## **TECHNICAL SERVICE BULLETIN**

Instrument Panel (IP) Topper Rub/Scratch/Buzz Noise From Right Front Passenger Side - Built On Or Before 29-

Ford	Built on or before 29-June-2023
2024 Mustang

Figure 1 - View from right side of the vehicle with flock tape installed

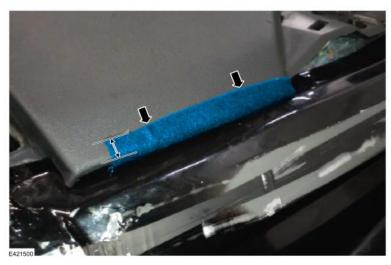
Issue: Some 2024 Mustang vehicles built on or before 29-June-2023 may exhibit a rub/scratch/buzz noise coming from the right front passenger side of the IP topper. This may be due to contact between the IP topper contacting sheet metal by the defroster grille. To correct the condition, follow the Service Procedure to remove the windshield and apply flock tape to the leading edge of the IP topper.

- 3. Unclip the sun load sensor from the defroster grille.
- **4.** Remove the front windshield. Refer to WSM, Section 501-11, General Procedures, Fixed Glass.
- 5. Obtain a full section (6 in. long x 1.75 in. wide x .0625 in. thick) of flock tape (fuzzy) strip tape from the Rotunda Squeak and Rattle Kit or obtain flock tape separately from the kit. Wrap the flock tape around the leading edge of the IP topper as seen in Figures 1-2 with only 10 mm of the flock tape should be exposed on the top side of the IP topper, isolating the IP topper from directly touching the sheet metal.
